ADDENDUM No. 3

REQUEST FOR QUOTATIONS No.: 1220-040-2017-011

TITLE: **NEWTON SENIORS CENTRE INTERIOR
RENOVATION**

ADDENDUM ISSUE DATE: January 5, 2017

Homogeneous Sheet Flooring

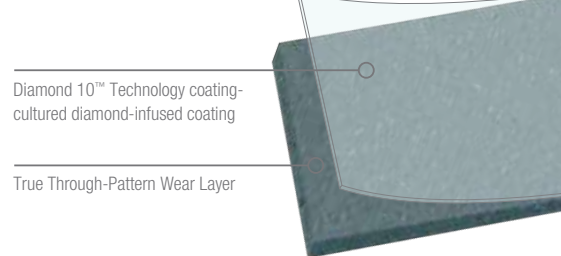
Q10: Attached is the Specification page for the ColorArt Homogeneous vinyl flooring (medintone and medintech) for our proposed alternate to the specified sheet vinyl.

A10: Homogeneous vinyl flooring (medintone and medintech) is approved as an acceptable alternative to the sheet vinyl specified in the solicitation documents. See attached spec. sheet.
